SERVICE *No. 366*
LETTER

TO: Distributors, Dealers, Certified Service Centers and Owners
SUBJECT: Nose Gear Clevis
MODELS AFFECTED: PA-24 and PA-24 "250" Comanches - Serial Nos. 24-1 to 24-2609 inclusive

SERVICE LETTER NO. 366

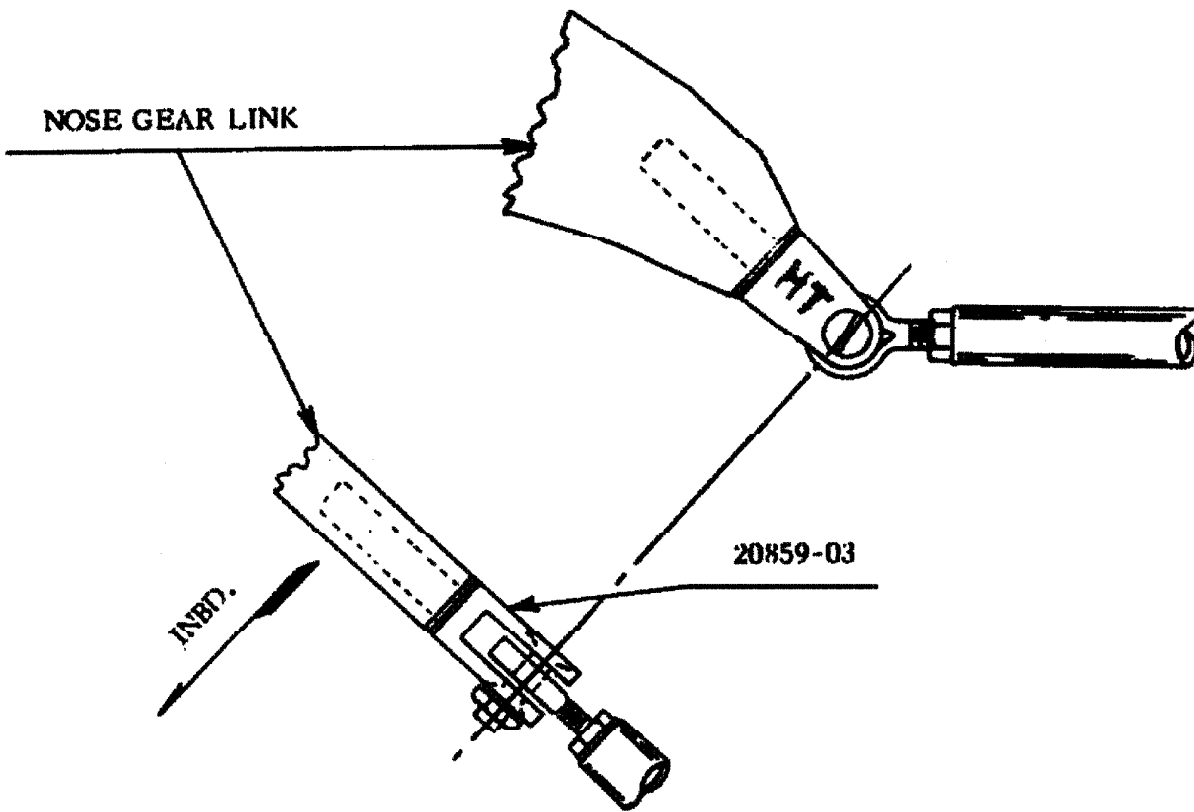
A new high strength nose gear clevis, part number 20859-03, is available to replace the nose gear clevis with which the early models of Comanche aircraft were equipped.

This new clevis may be identified by the letters "H.T." etched on the side of the fitting. We are of the opinion that since this new high strength fitting will provide longer service life, the owners and operators of the affected aircraft should replace the present clevis with this improved one. See sketch below

This clevis, when installed, must be tight in the forgoing (13 to 40 ft. lbs. torque) and nut must be inboard.
